PCN Number:	20181116001.1	PCN Date:	Nov 19 2018
Title:	Qualification of additional Fab site (RFAB) and Assembly/Test site (AP1) options for the TLV6002 device family		
Customer Contact:	PCN Manager	Dept:	Quality Services
Proposed 1st Ship Date:	Feb 19 2019	Estimated Sample Availability:	Date provided at sample request.

Texas Instruments is pleased to announce the qualification of additional Fab site (RFAB) and Assembly/Test site (AP1) options for the TLV6002 device family.

Sample product shipping label (not actual product label)

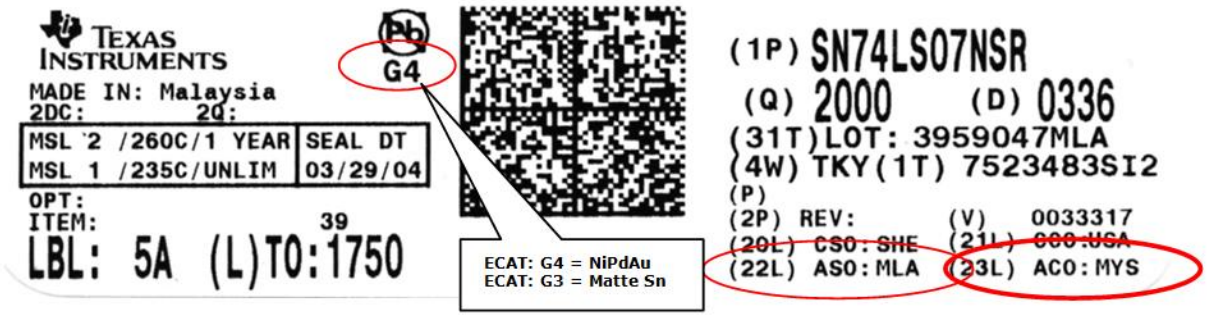
Changes to product identification resulting from this PCN:

Fab Site Information:

Chip Site	Chip Site Origin Code (20L)	Chip Site Country Code (21L)	Chip Site City
DP1DM5	DM5	USA	Dallas
RFAB	**RFB**	**USA**	**Richardson**

Assembly Site Information:

Assembly Site	Assembly Site Origin (22L)	Assembly Country Code (21L)	Assembly City
TI Mexico	MEX	MEX	Aguascalientes
Amkor Phi	**AKR**	**PHL**	**Cupang, Muntinlupa City**
